ADDENDUM NO: 1

PROJECT: Security Improvements and Front Office Renovation

PROJECT NO: 2024128

DATE: 03/24/2025

GROUND FLOOR CEILING DEMOLITION PLAN
 2 AD201 SCALE: 1/8" = 1'-0"

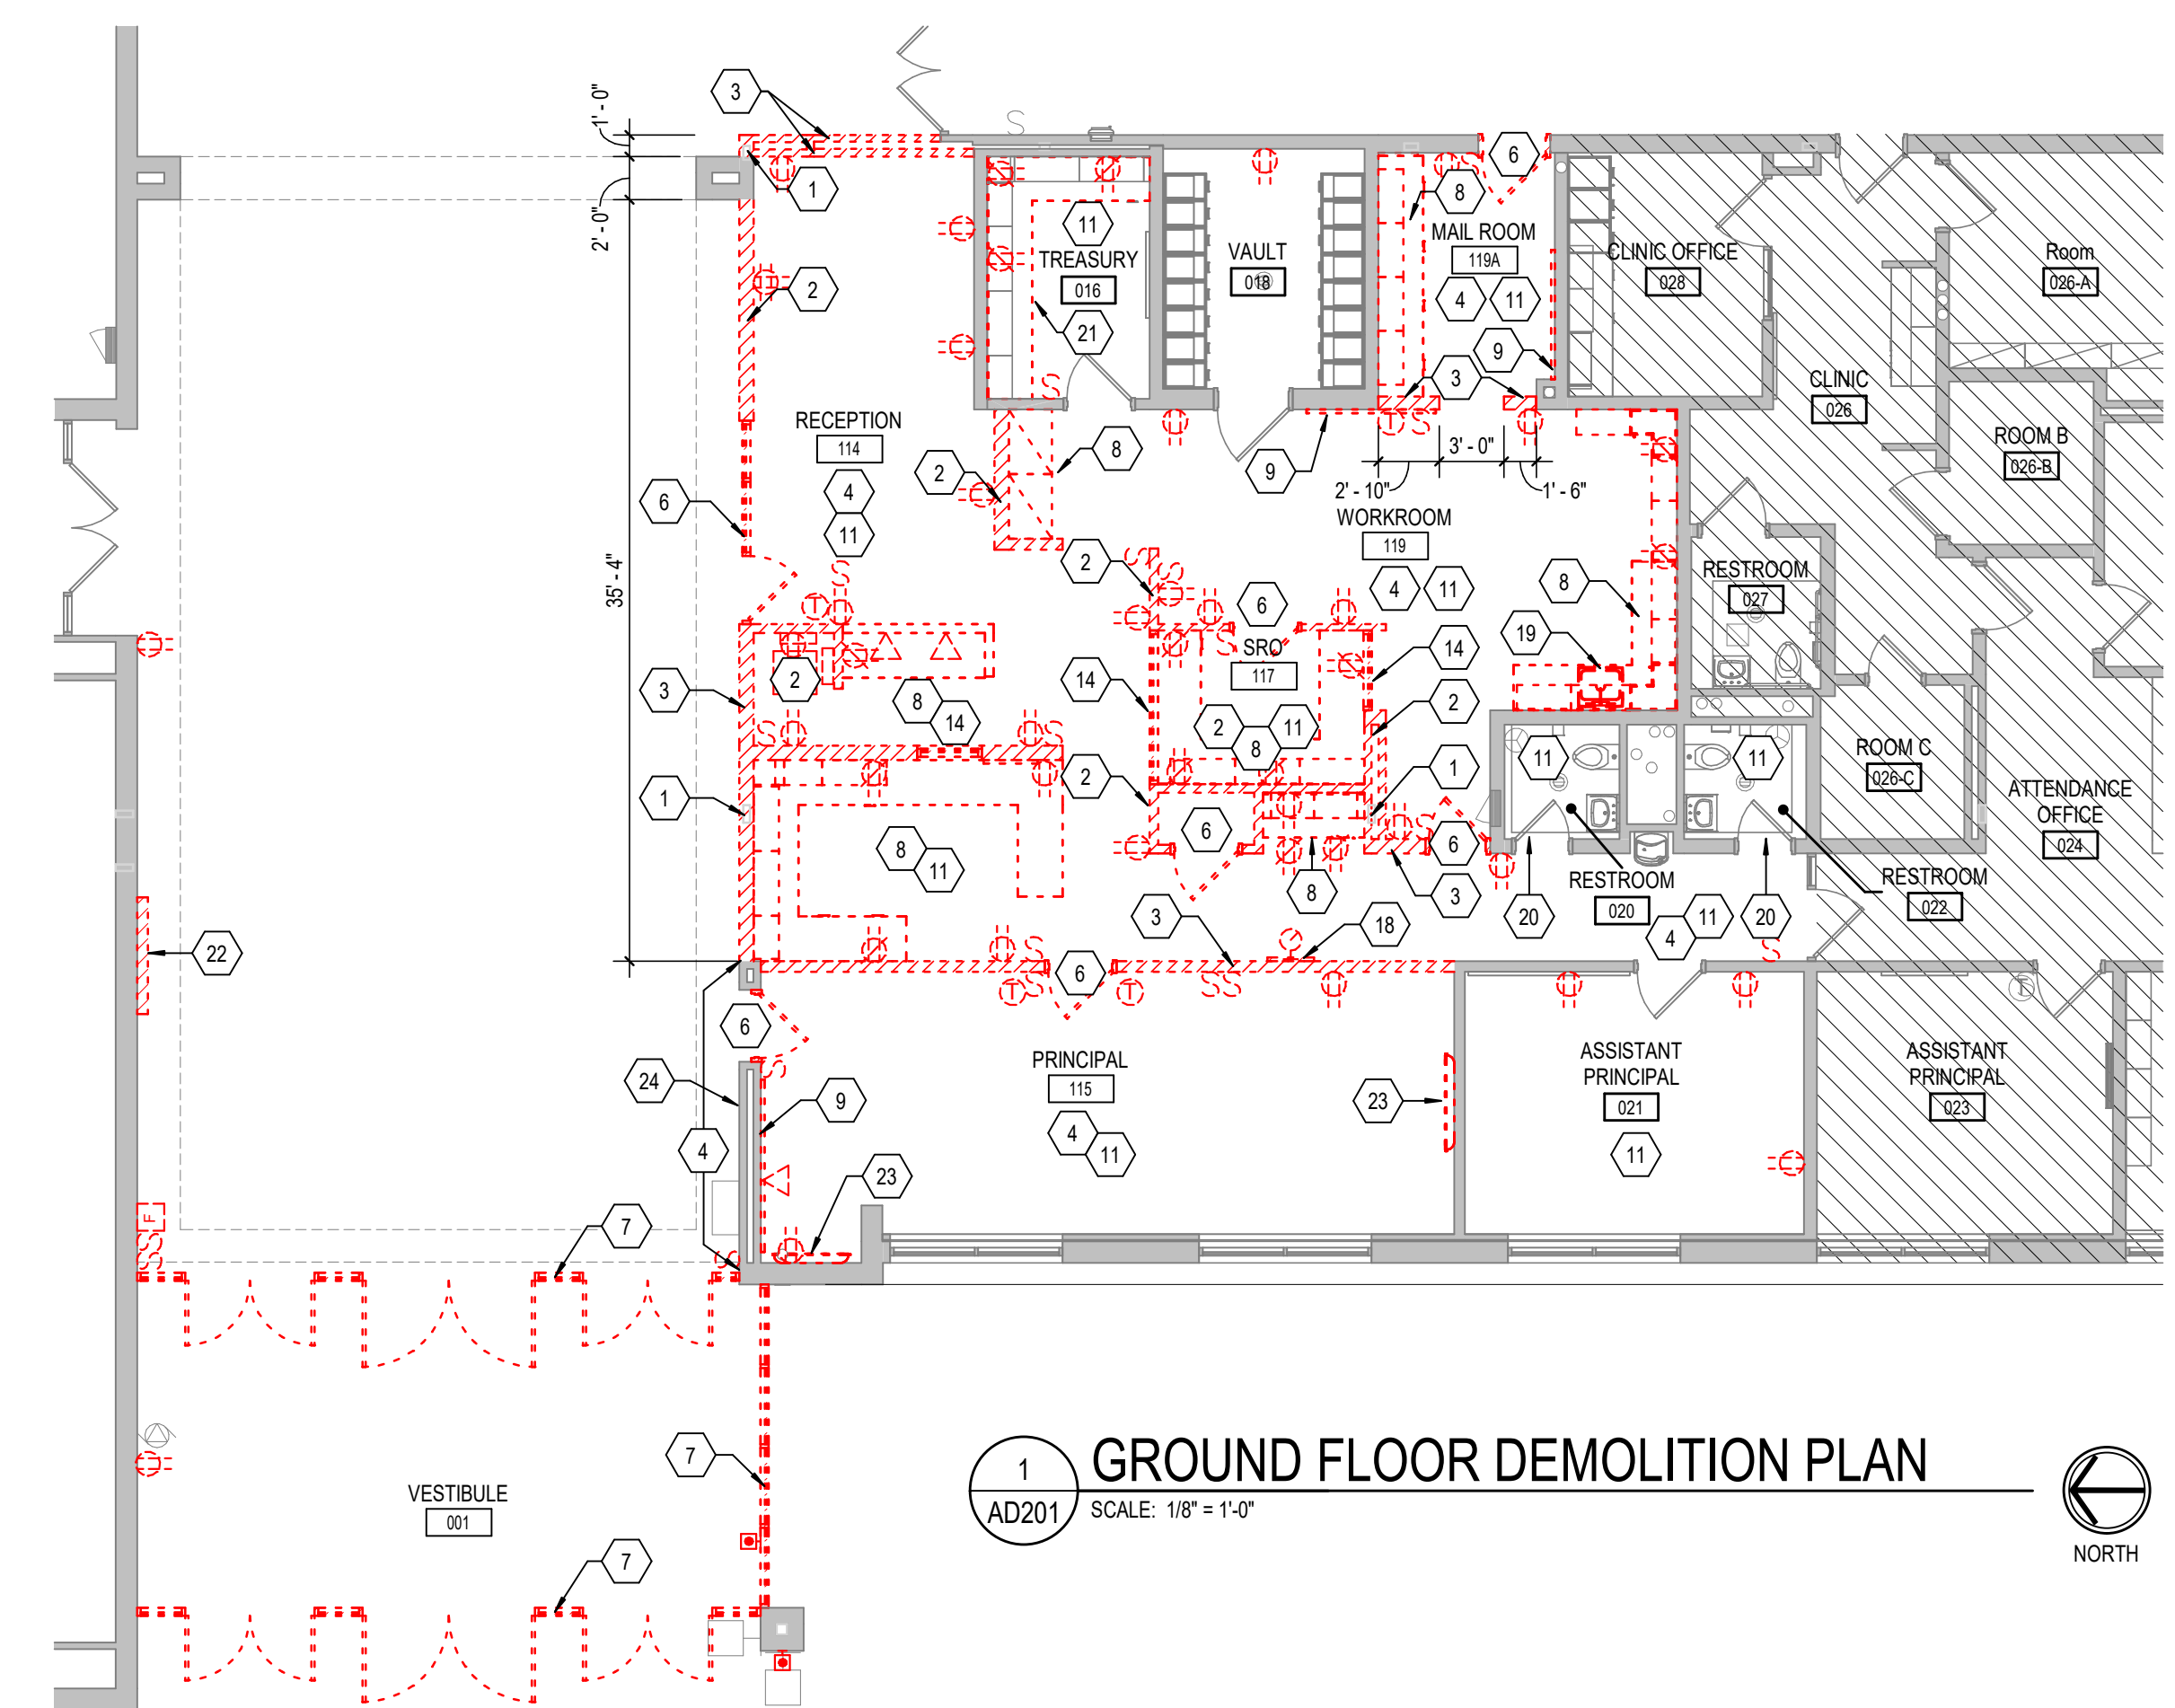
3.01 AD201 – GROUND FLOOR DEMOLITION PLAN

- A. Include Demo Note 4 to ceiling plan for corridor ceiling

5 ENLARGED PLAN DETAIL
A401 SCALE: 1 1/2" = 1'-0"

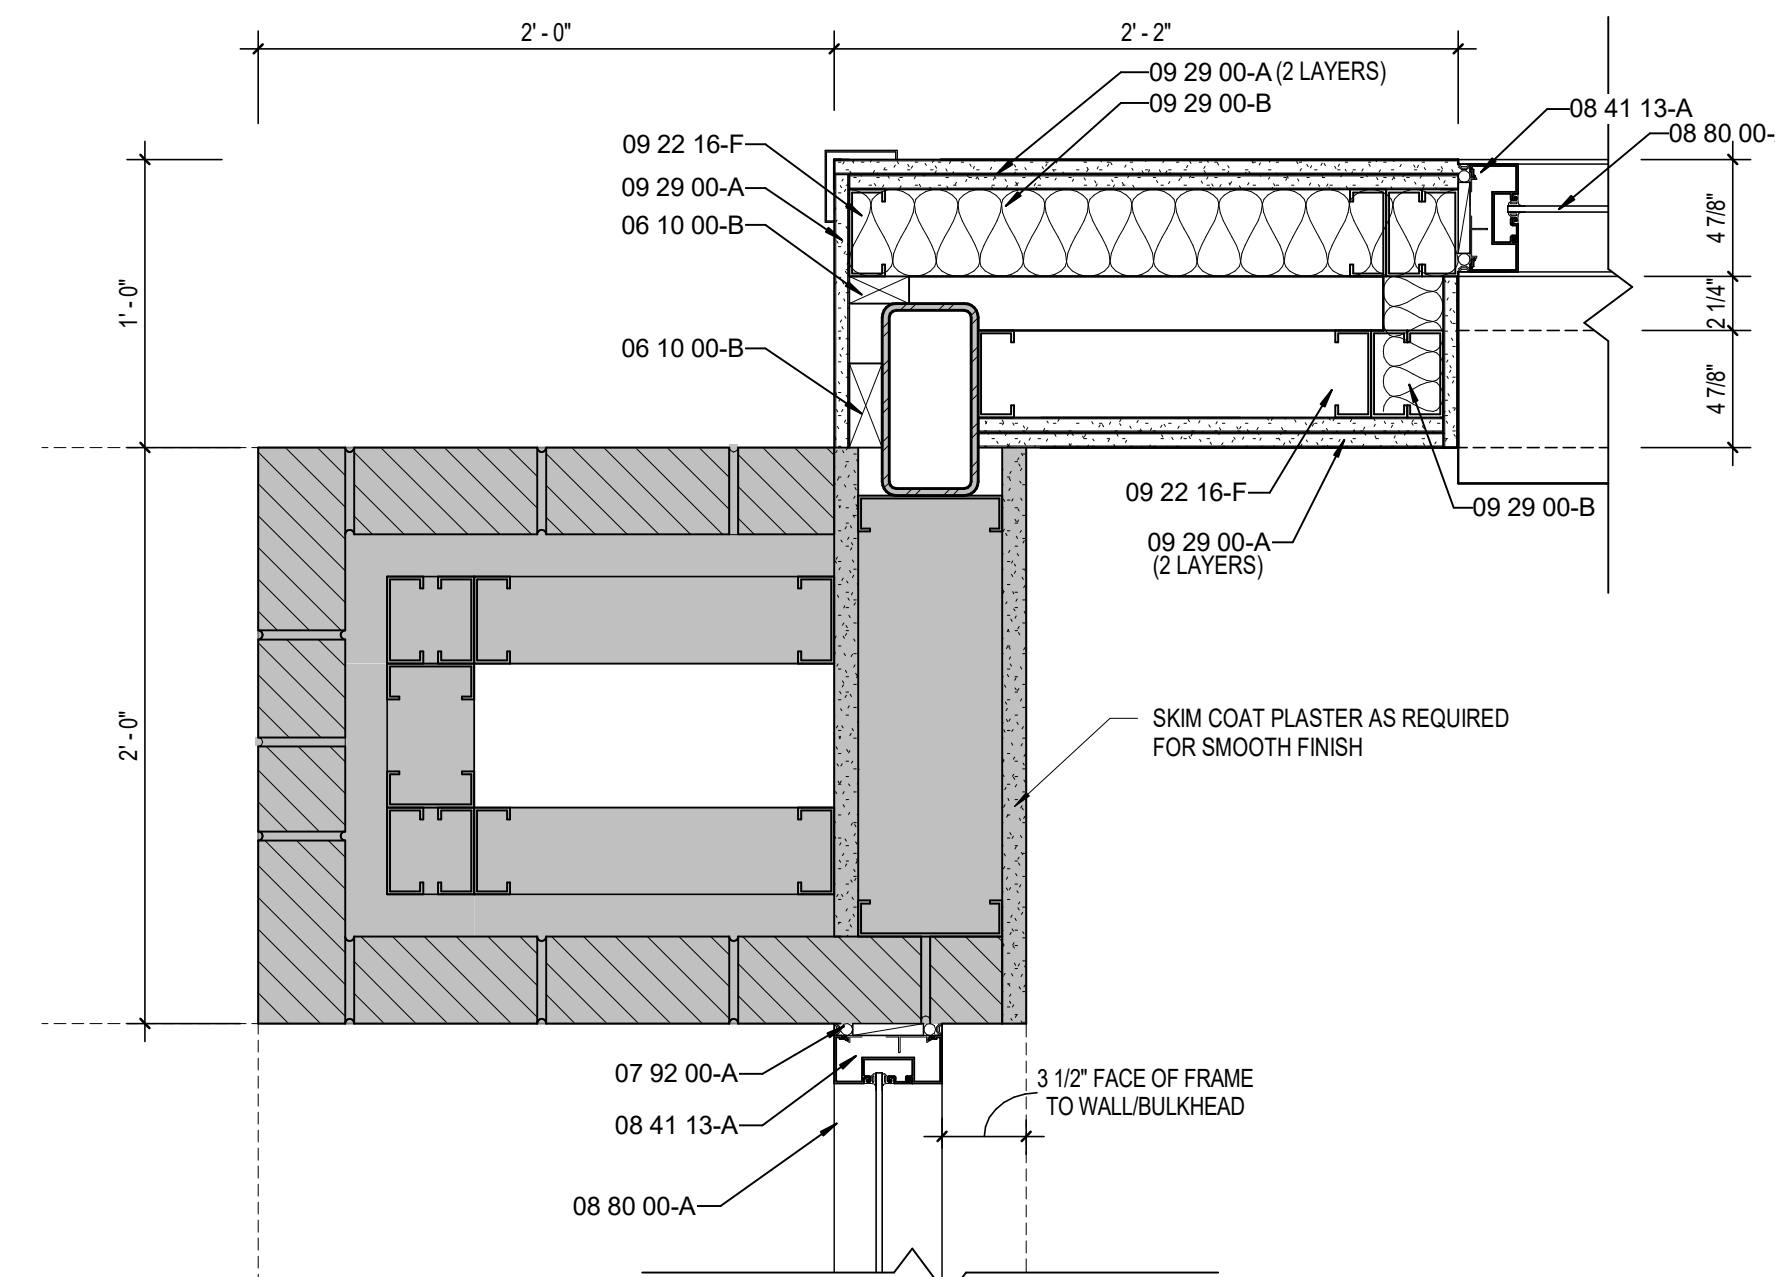
3.03 A401 – WALL SECTIONS

- A. **Add** detail 5/A401

FRAME ELEVATIONS
SCALE: 1/4" = 1'-0"

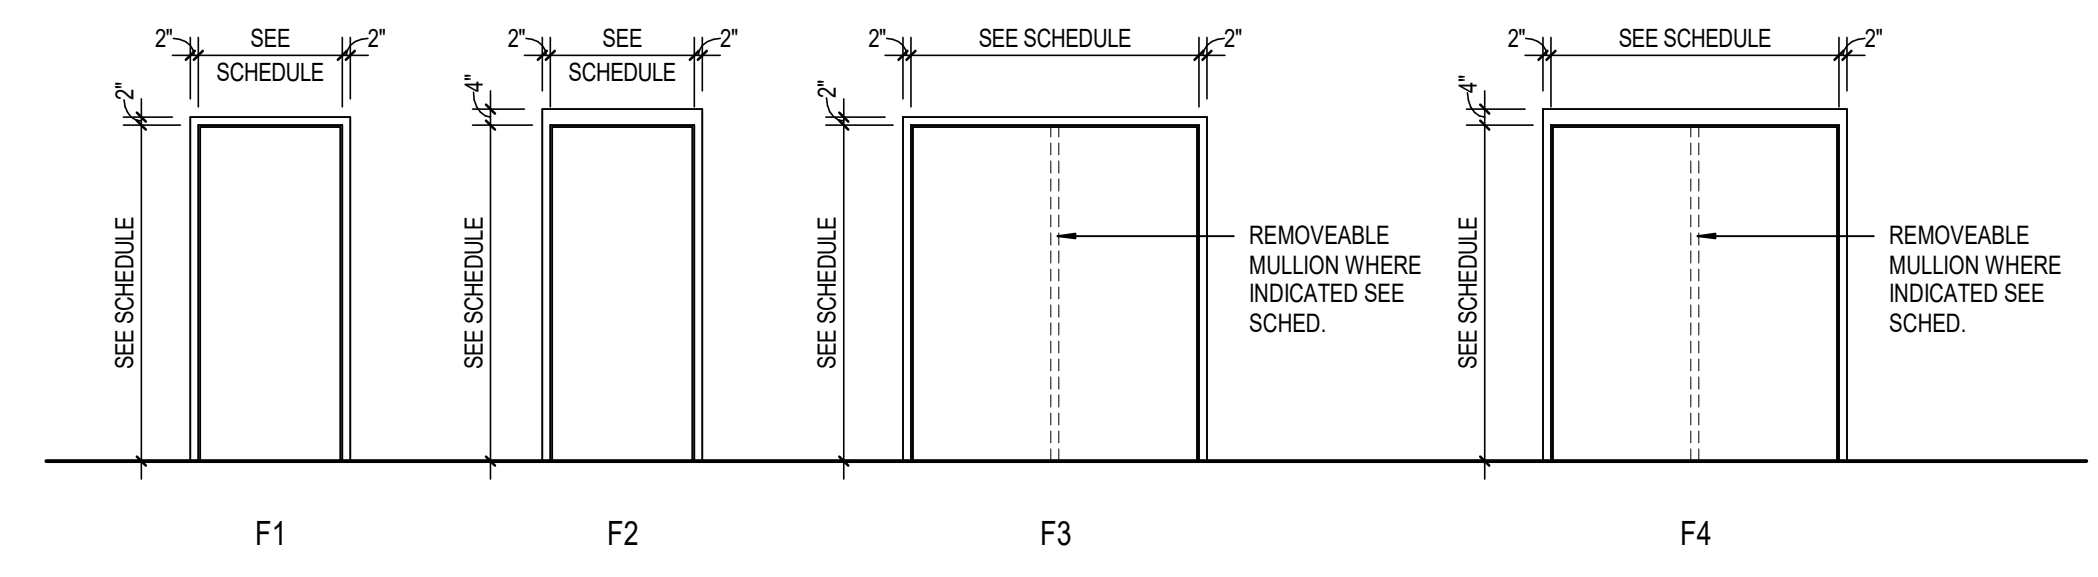
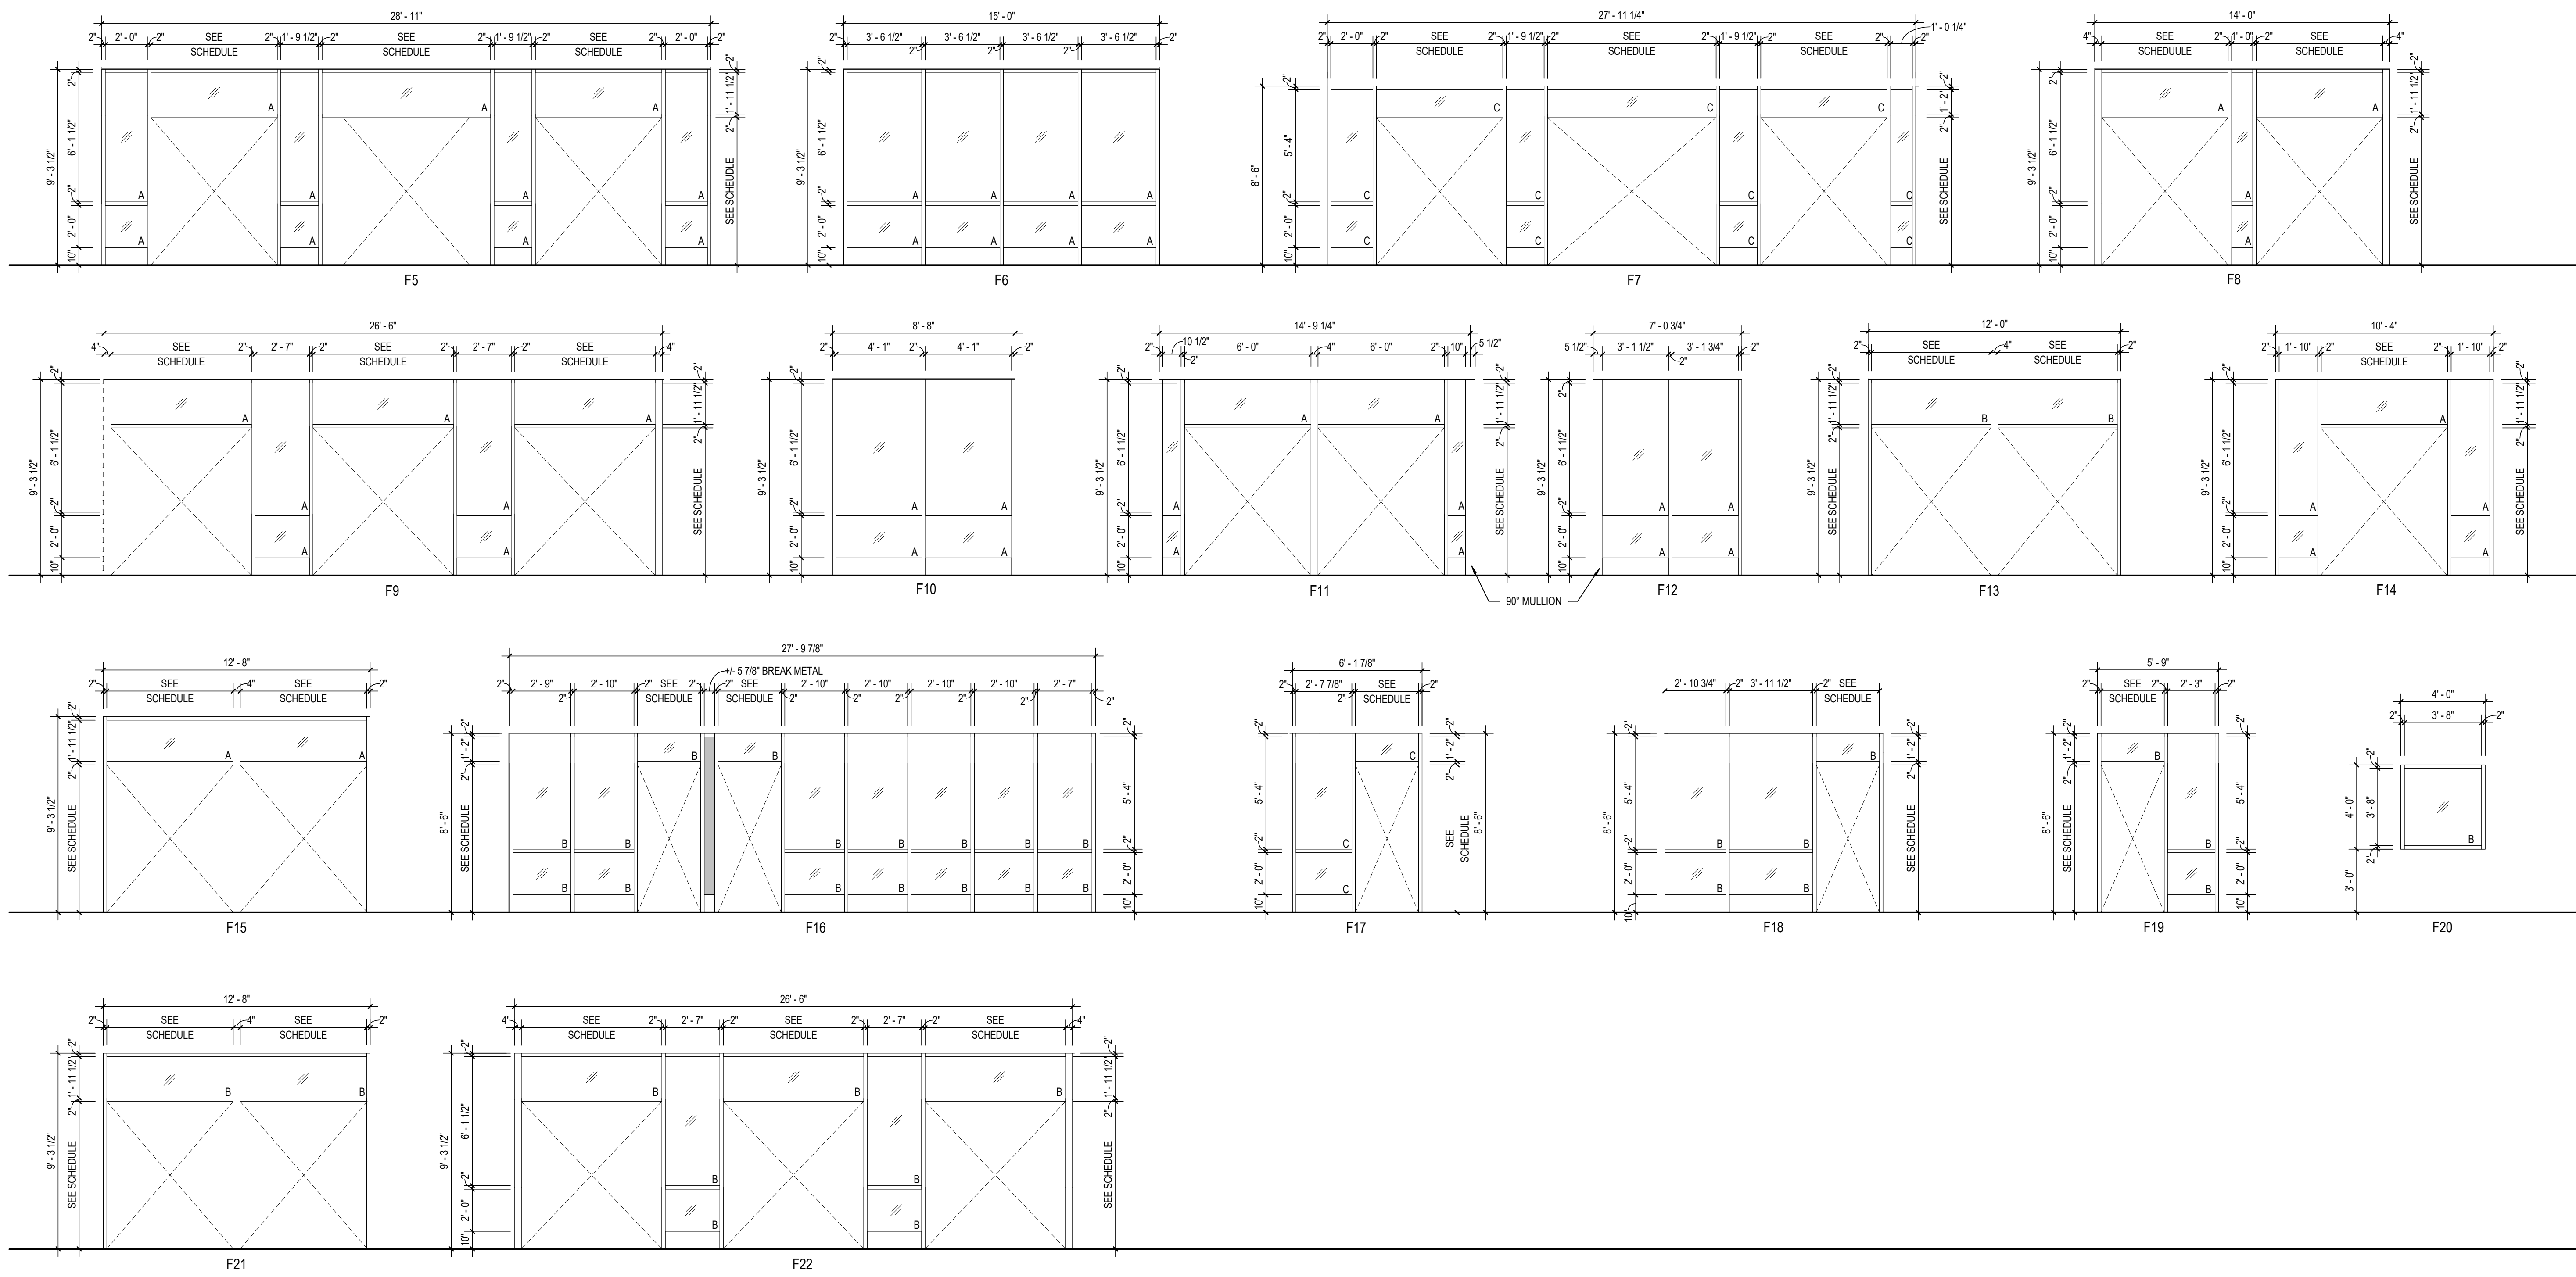
3.04 A501 – DOOR AND FRAME SCHEDULE

- A. Revise the Exterior Door schedule to have a thickness of **2"** for thermally broken doors.
- B. Revise frame elevations to indicate Glass Type **B** for glazing at doors: **5E-C and 5E-D**
- C. **Add** frame elevations **F21 and F22**. Elevations included for revision to glass type.
- D. Revise 5/16" CLEAR ~~TEMPERED~~ GLAZING to be 5/16" CLEAR **LAMINATED** GLAZING
- E. Revise Frames **F7, F16 and F17**
